Addendum No. 1

South Side Ditch Drainage Improvements – Phase 1

For City of Litchfield
Montgomery County, Illinois

H&A File No. 2134-301
October 16, 2020

4 OF 22 SHEETS

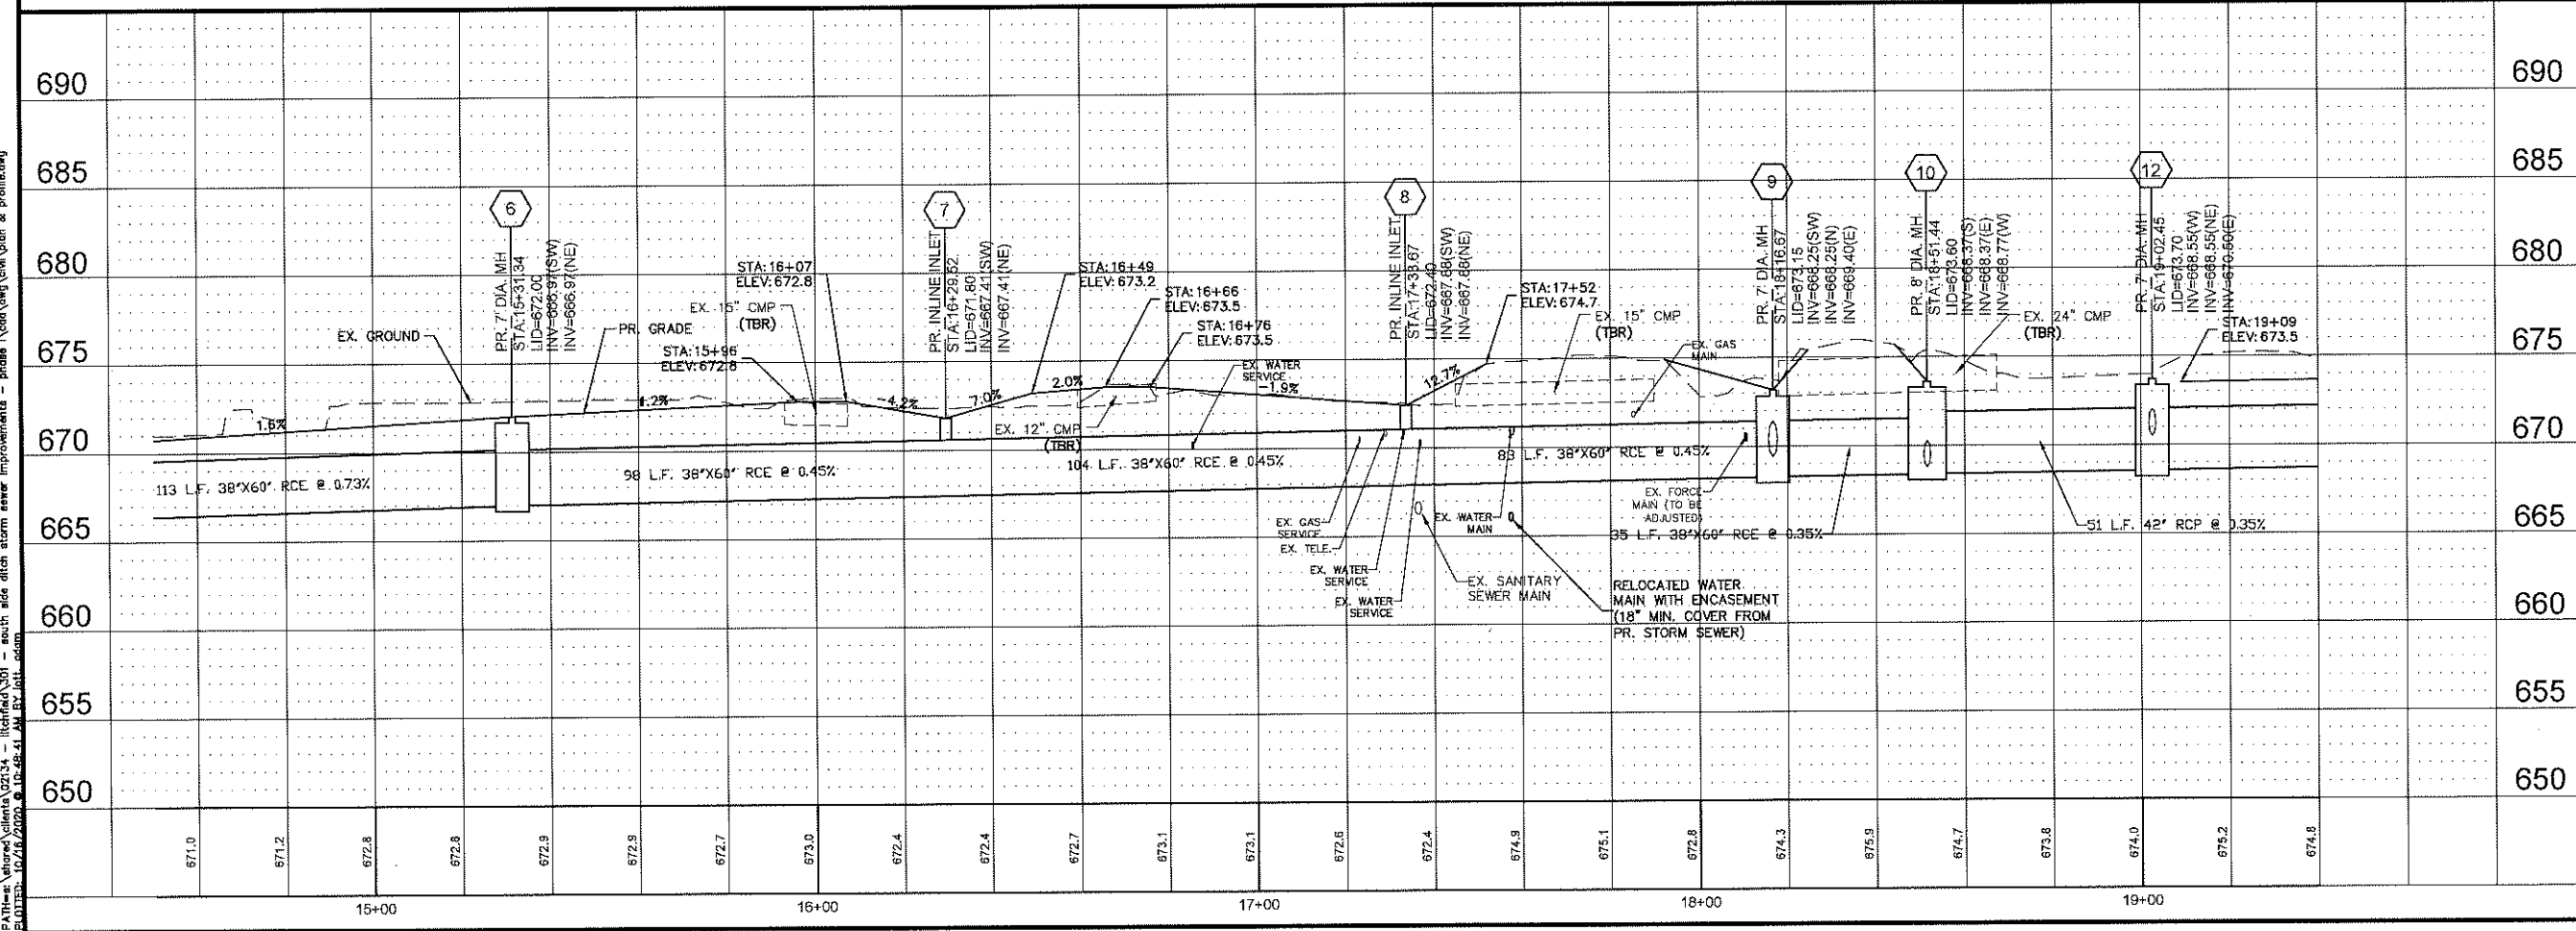
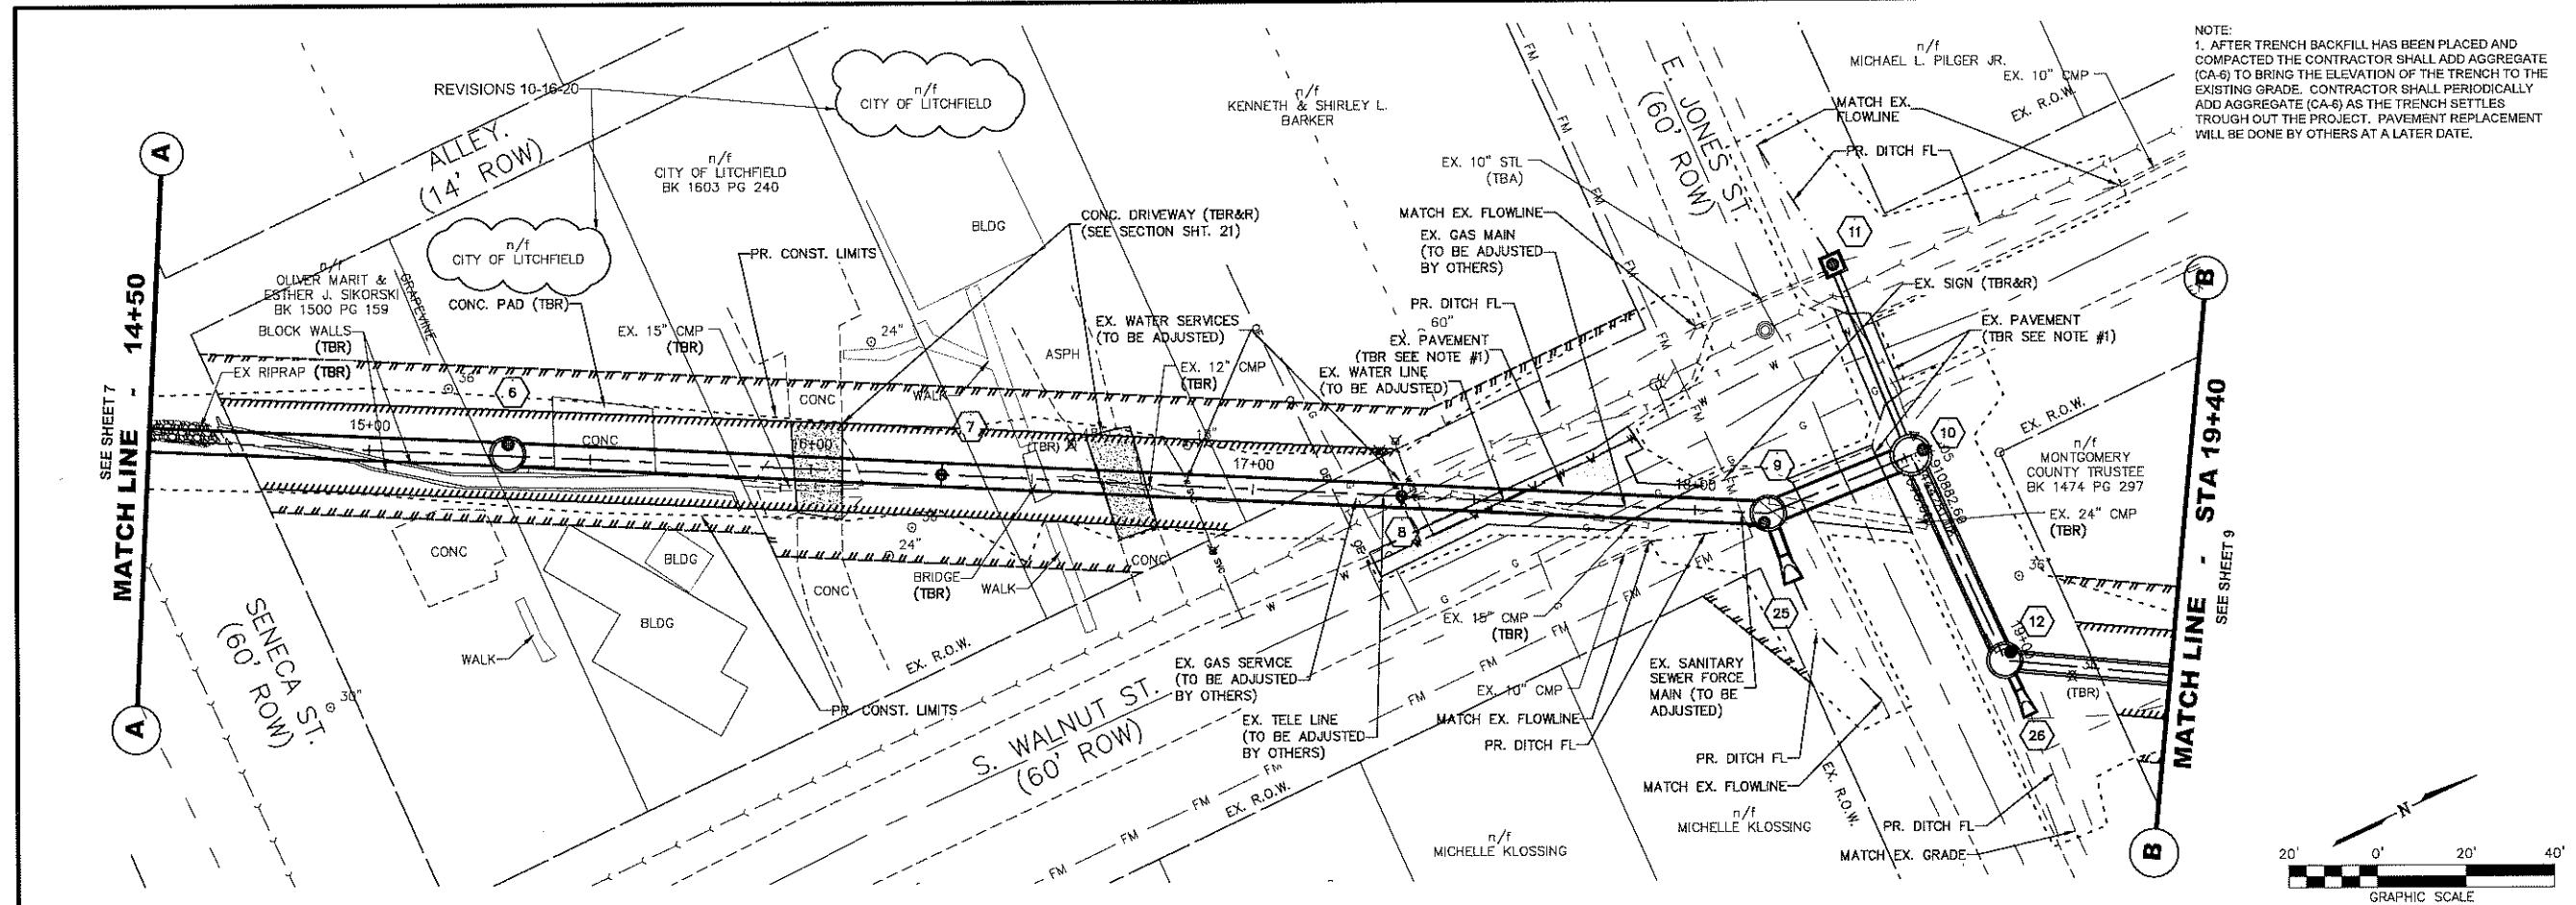
Sheet 4: Changed storm sewer schedule
